### APPEAL SUMMARY

<b>Appeal ID:</b> 18962	<b>Project Address:</b> 631 SE Taylor St
<b>Hearing Date:</b> 2/6/19	<b>Appellant Name:</b> Kathy Johnson
<b>Case No.:</b> B-015	<b>Appellant Phone:</b> 503.477.9165
<b>Appeal Type:</b> Building	<b>Plans Examiner/Inspector:</b> Steven Mortensen, Ed Marihart
<b>Project Type:</b> commercial	<b>Stories:</b> 3 <b>Occupancy:</b> R-2, B <b>Construction Type:</b> V-B
<b>Building/Business Name:</b> The Rose Apartments	<b>Fire Sprinklers:</b> Yes - Proposed throughout
<b>Appeal Involves:</b> Alteration of an existing structure	<b>LUR or Permit Application No.:</b>
<b>Plan Submitted Option:</b> pdf [File 1]	<b>Proposed use:</b> Existing R-2 and B to remain

PROJECT DESCRIPTION	
PROJECT NAME: THE ROSE APARTMENTS	PROJECT ADDRESS: 631 SE TAYLOR STREET, PORTLAND, OREGON
ORIGINAL CONSTRUCTION: 1910

2 THIRD STORY LIFE SAFETY PLAN - APPEAL  
GA3 1/8" = 1'-0"

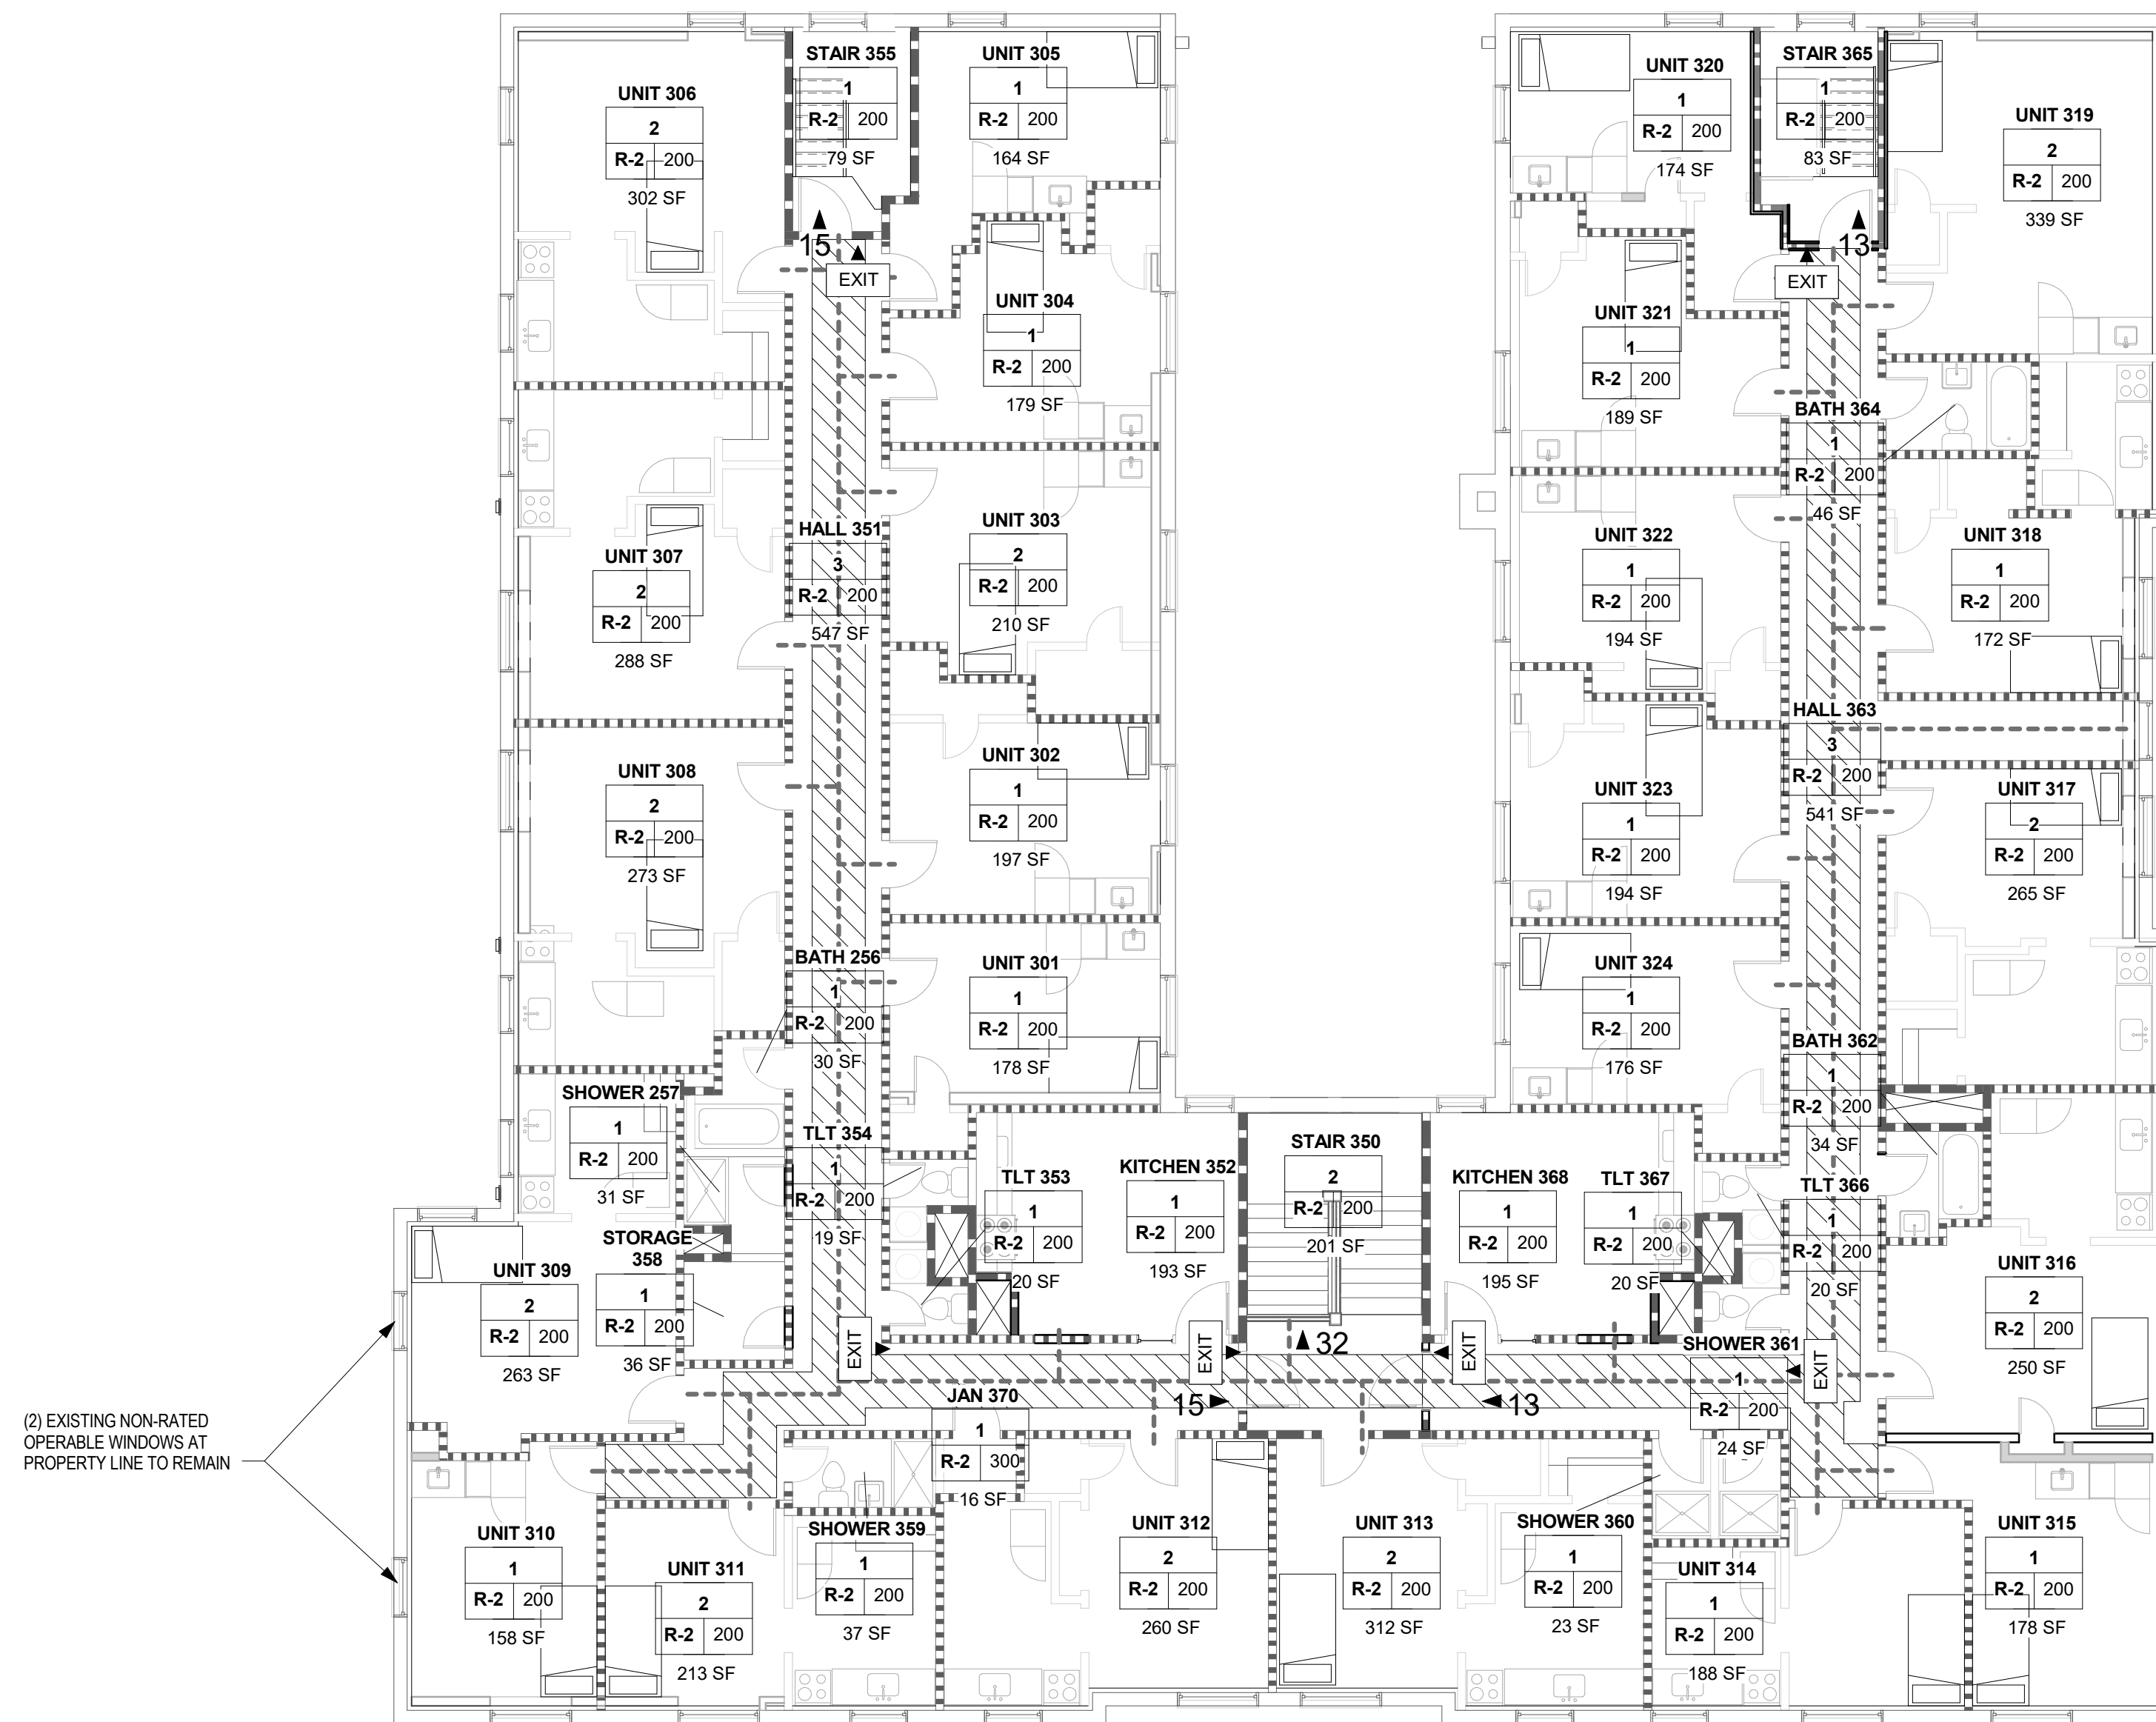
<b>Code Section</b>	Table 705.8 Allowable Openings Based on Fire Separation Distance
<b>Requires</b>	Unprotected openings less than 3' from a property line are not permitted.
<b>Proposed Design</b>	The six unprotected operable windows at the west property line shall remain. The building shall be equipped with a full NFPA 13 sprinkler system throughout. See GA2 and GA3.
<b>Reason for alternative</b>	<p>A portion of the west walls falls on the property line. There are six existing non-rated operable windows in this portion of the west wall. The windows provide natural light and fresh air required for sleeping rooms and cannot be removed or fixed in place because doing so would create a less safe condition for the occupants. The windows were permitted in 2009 and allowed by Appeal #6358. The project scope does not include any new windows or changes to existing windows. Per the Preliminary Life Safety Meetings, this appeal is only required because of the proposed removal of the building from the Chapter 13 program.</p> <p>Additionally, the project scope includes a full voluntary ASCE 41 BPOE structural seismic upgrade, the addition of a full voluntary NFPA 13 sprinkler system (in lieu of the required 13R system) and fire alarm upgrades. The two existing enclosed exit stairs at the north wings of the building will be repaired as necessary to achieve the 1- and 2-hour required fire barrier construction. These scope items greatly increase the overall safety of the building from its existing condition.</p>

- 1. Removal of building from Chapter 13 status: Hold for additional information.**
  - 2. Sprink protection of windows in egress court: Hold for additional information.**
  - 3. Winder treads in 2 egress stairs: Hold for additional information.**
  - 4. Omission of handrail extensions in 2 egress stairs: Hold for additional information.**
  - 5. Unprotected windows at property line: Hold for additional information.**
  - 6. Unprotected operable windows in exterior wall of 2 Exit stair enclosures: Denied. Proposal does not provide equivalent Life Safety protection.**
  - 7. Unclosed exit access stair: Hold for additional information.**
- Appellant may contact John Butler (503 823-7339) with questions.**
